Re: Site Plan Application SPPL2025233
2148 Highway 3 - Roll Number 3310.491.028.07800
Responses to September 16, 2025 Letter

| COMMENT RESPONSE MATRIX | | | |

SITE PLAN APPLICATION SPPL2025233 2148 HIGHWAY 3 – ROLL NUMBER 3310.491.028.07800

Site Plan Application SPPL2025233

Drawing No. SWM-2

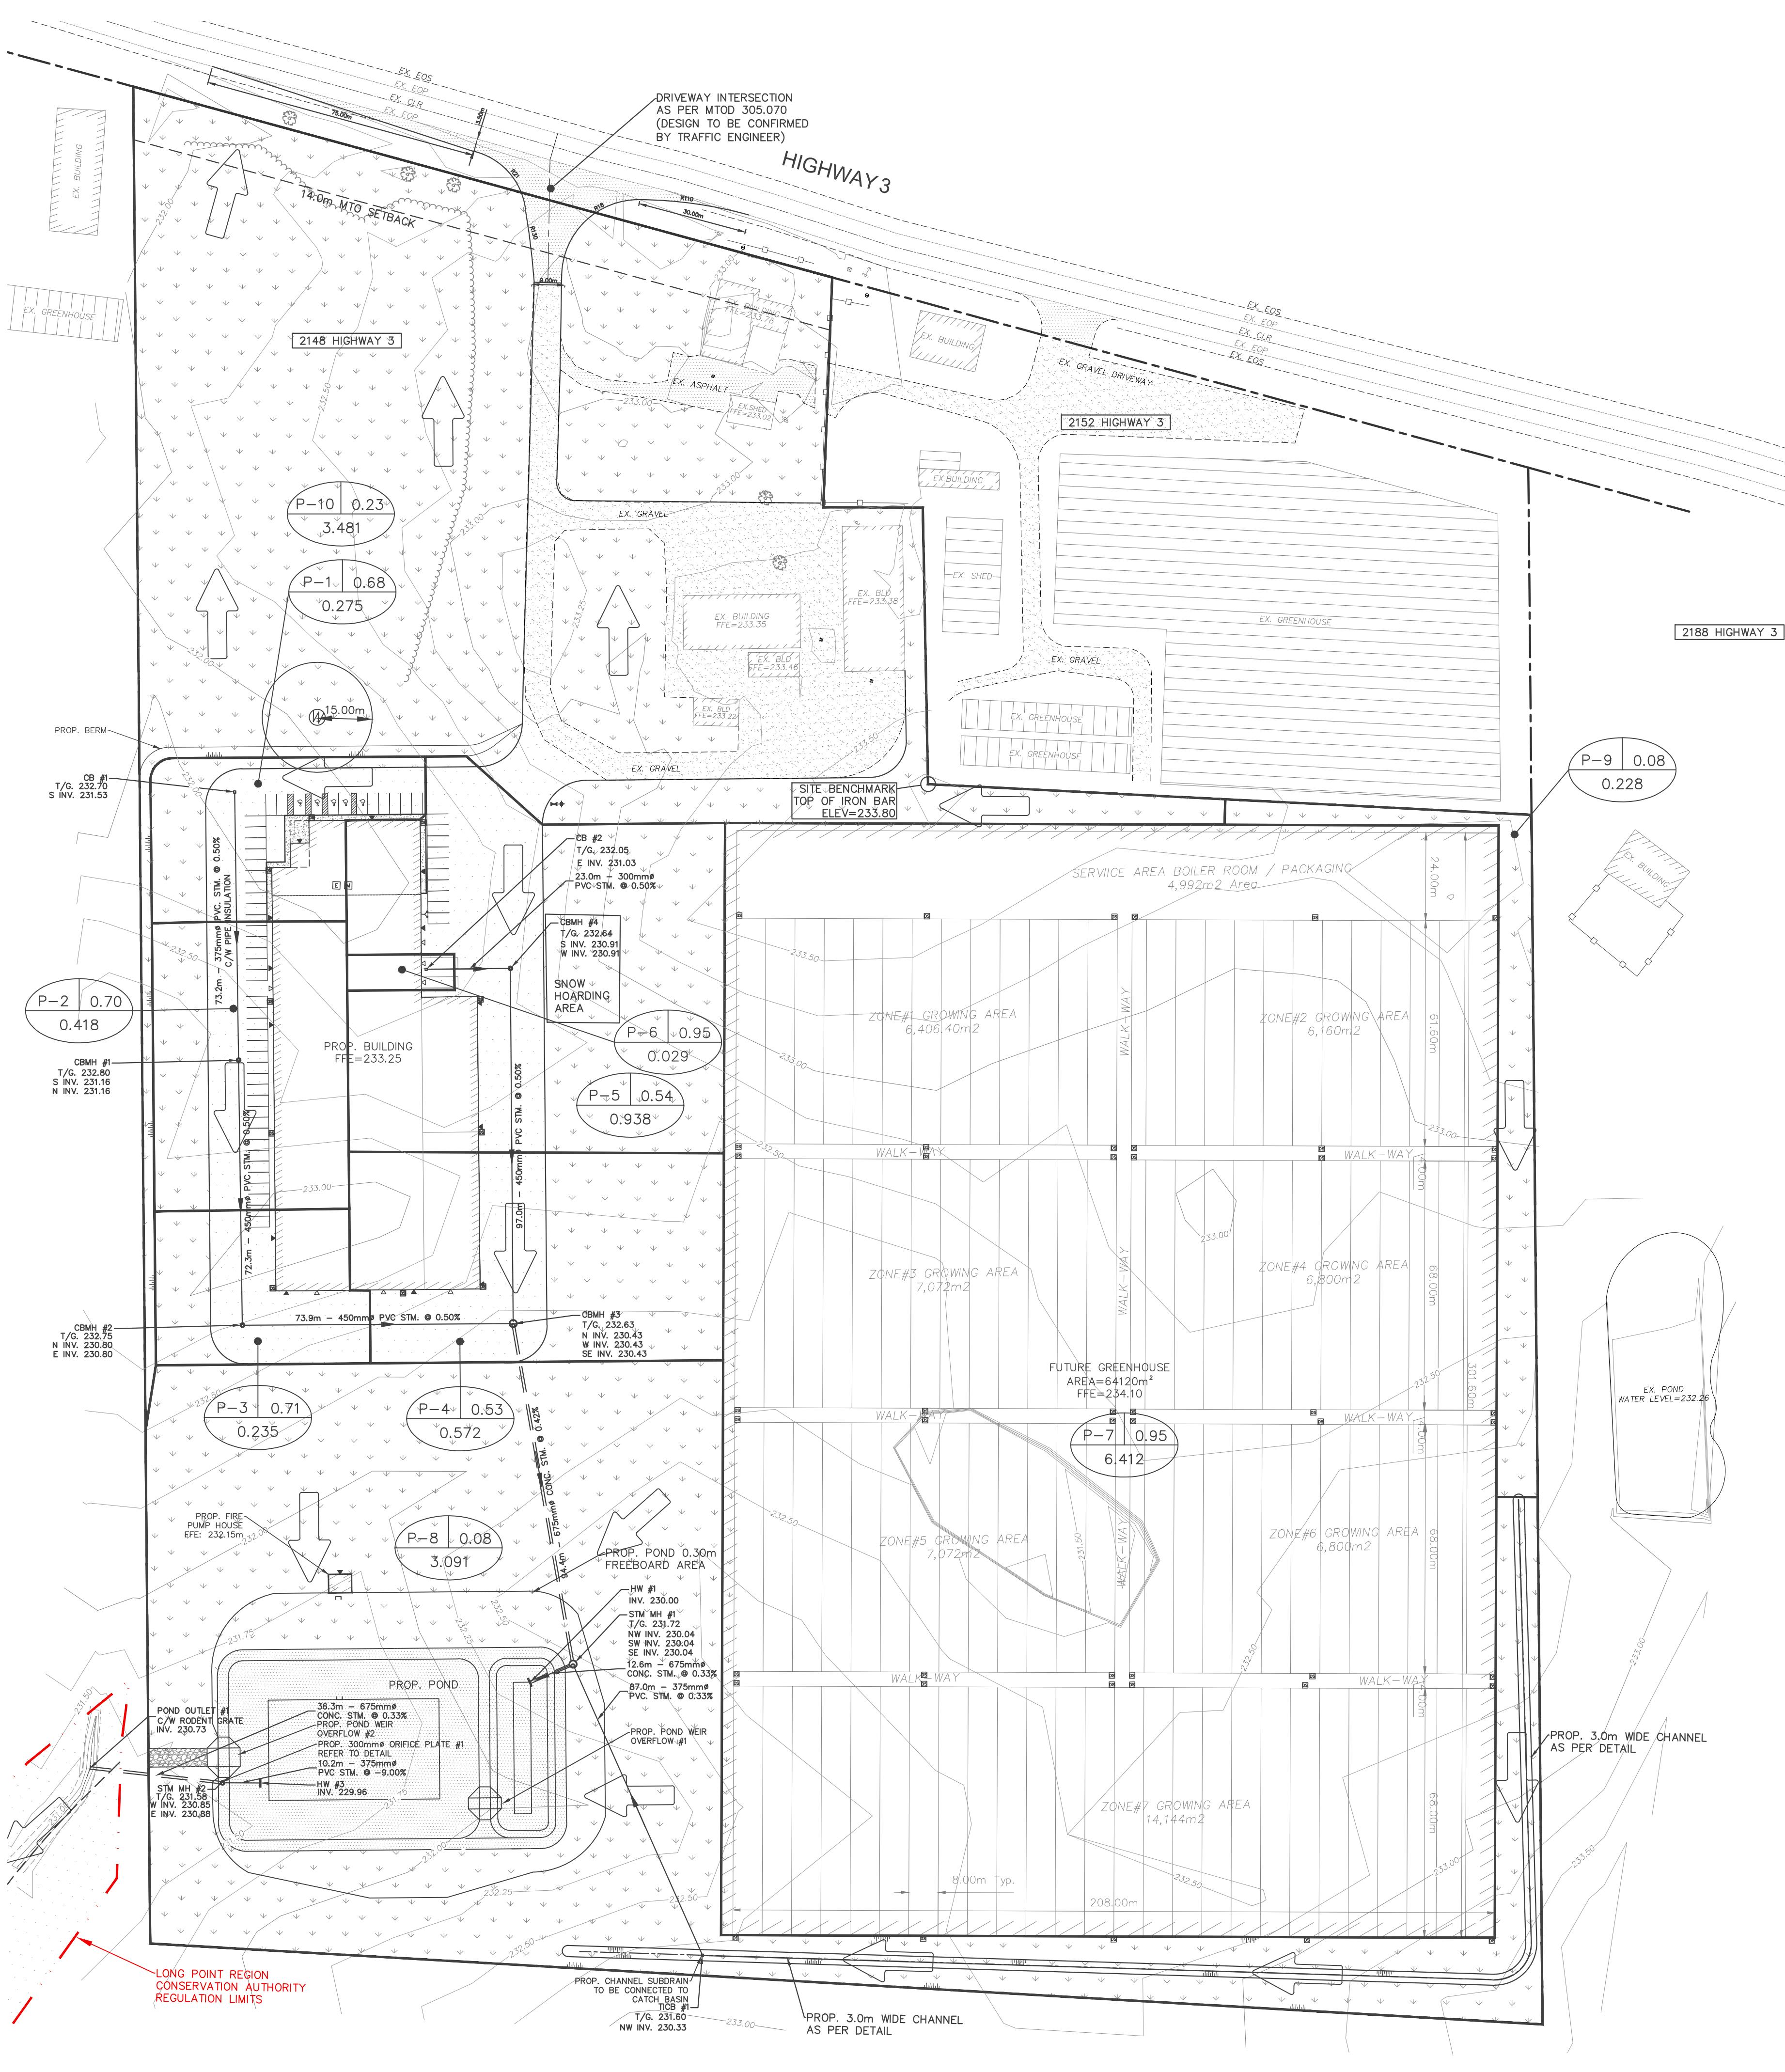
| COMMENT RESPONSE MATRIX | | | |
|-------------------------|---|--|---|
| | 1d) Location of pump house to be indicated on the civil drawings (if applicable) [OBC 3.2.5.18, NFPA 20] | Complete - Provided on Site Plan, Site Servicing plan, Site Grading Plan, Pond Plan, and Post Development Stormwater Drainage Plan | A1.01 SS-1 SG-1 PND-1 SWM-2 |
| | 2d) Location of pump house to be indicated on civil drawings (if applicable) [OBC 3.2.5.18, NFPA 20] | Complete - Provided on Site Plan, Site Servicing plan, Site Grading Plan, Pond Plan, and Post Development Stormwater Drainage Plan | A1.01 SS-1 SG-1 PND-1 SWM-2 |

J.D. McCullum
LICENCED PROFESSIONAL ENGINEER
NO. 10004895
PROVINCE OF ONTARIO
Drawing No. SG-1

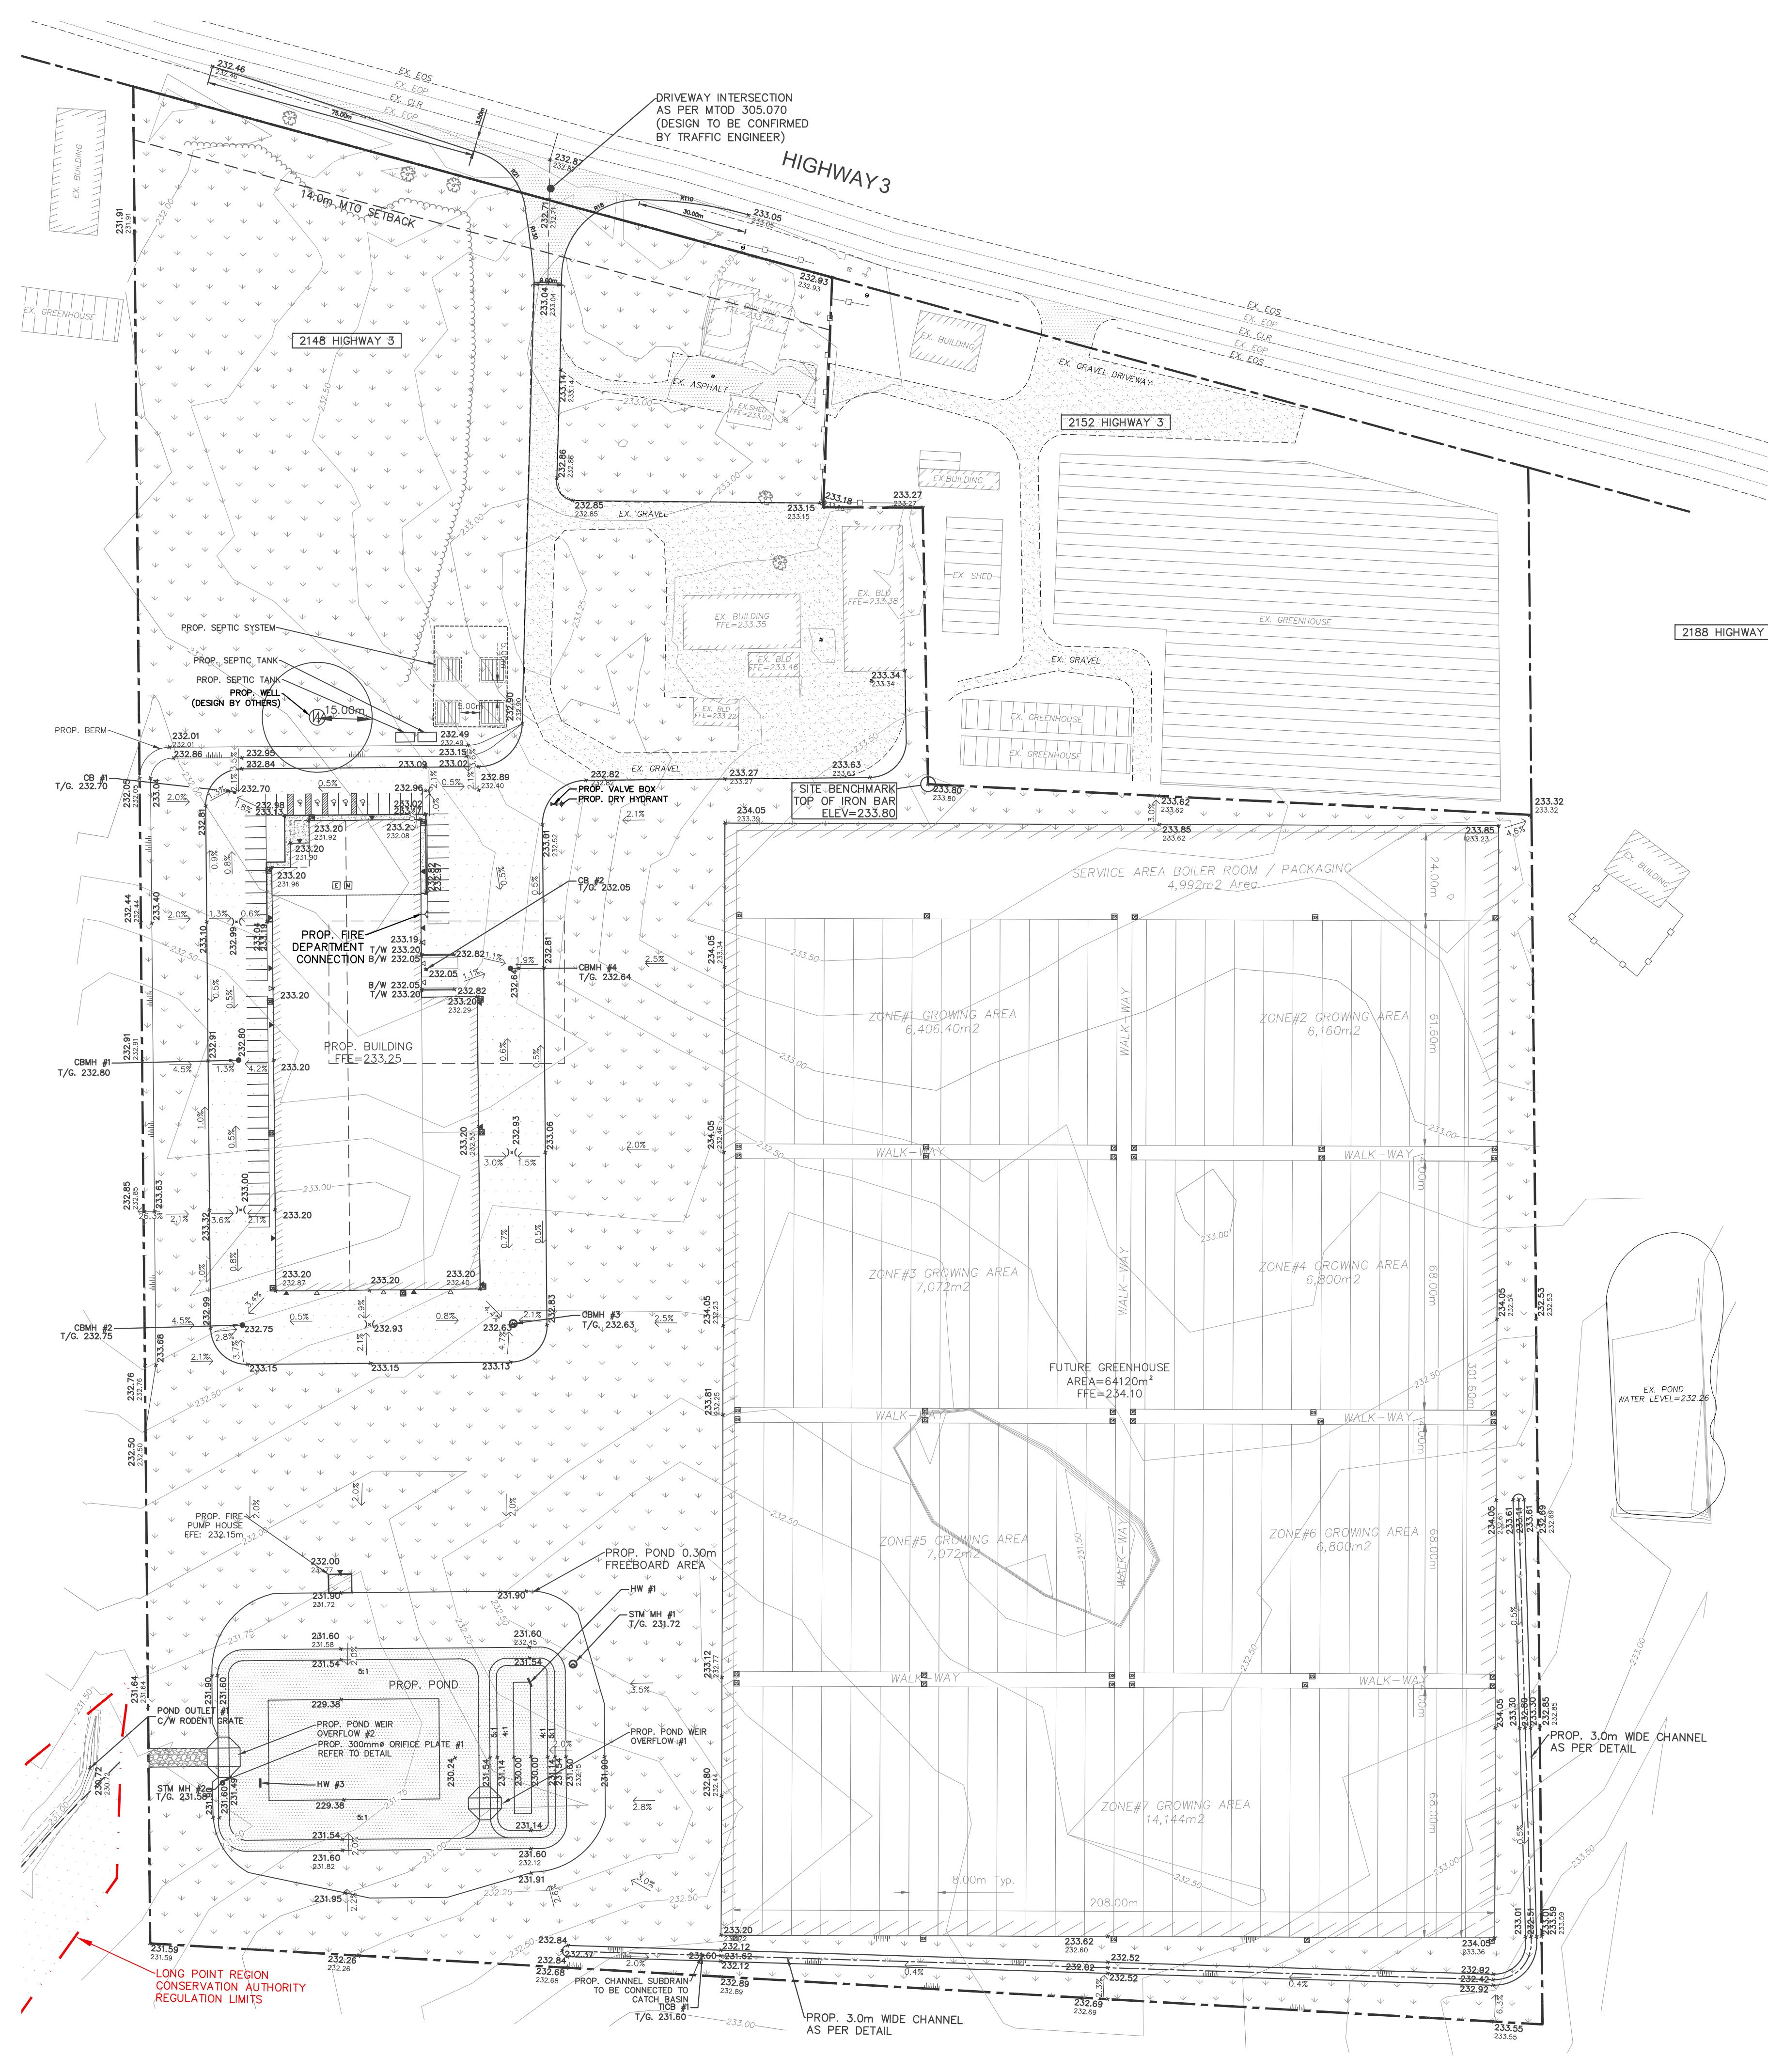
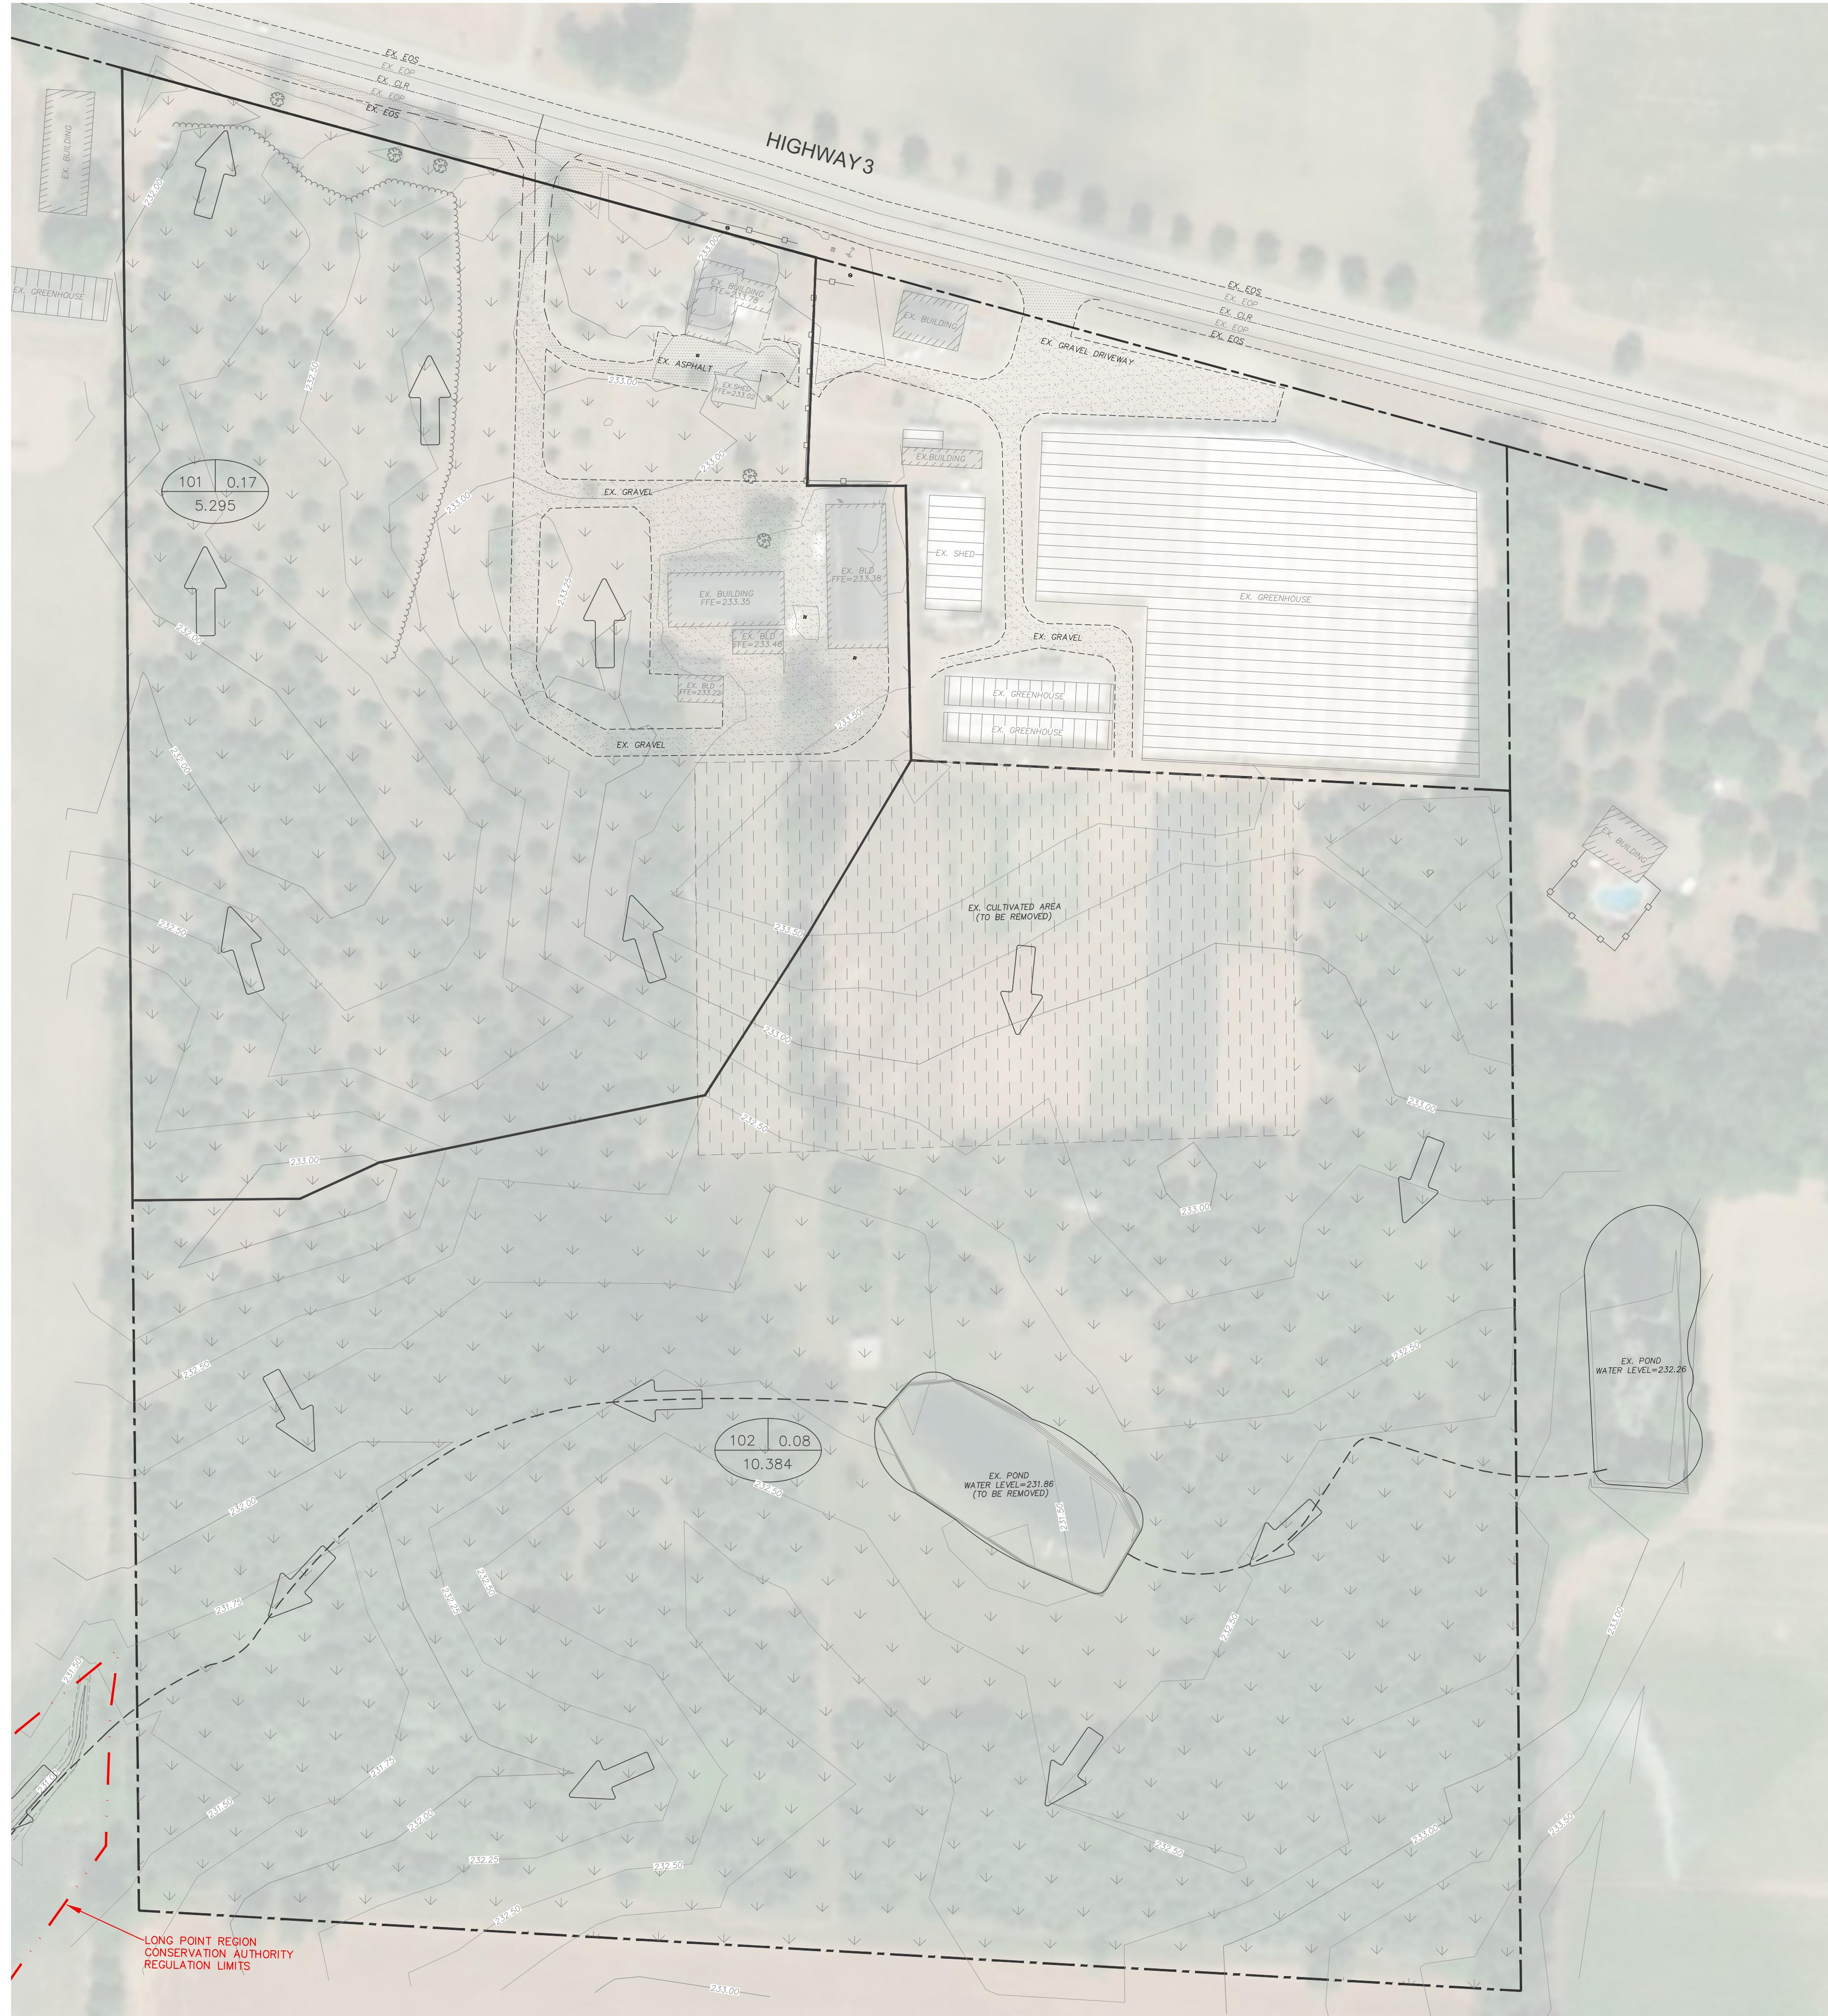
| COMMENT RESPONSE MATRIX | | | |
|-------------------------|---|--|---|
| | 1a) Location of fire department connection on industrial building is required | Complete - Provided on Site Plan, Site Servicing Plan, and Site Grading Plan | A1.01 SS-1 SG-1 |
| | 2a) Location of fire department connection on industrial building is required [OBC 3.2.5.15] | Complete - Provided on Site Plan, Site Servicing Plan, and Site Grading Plan | A1.01 SS-1 SG-1 |
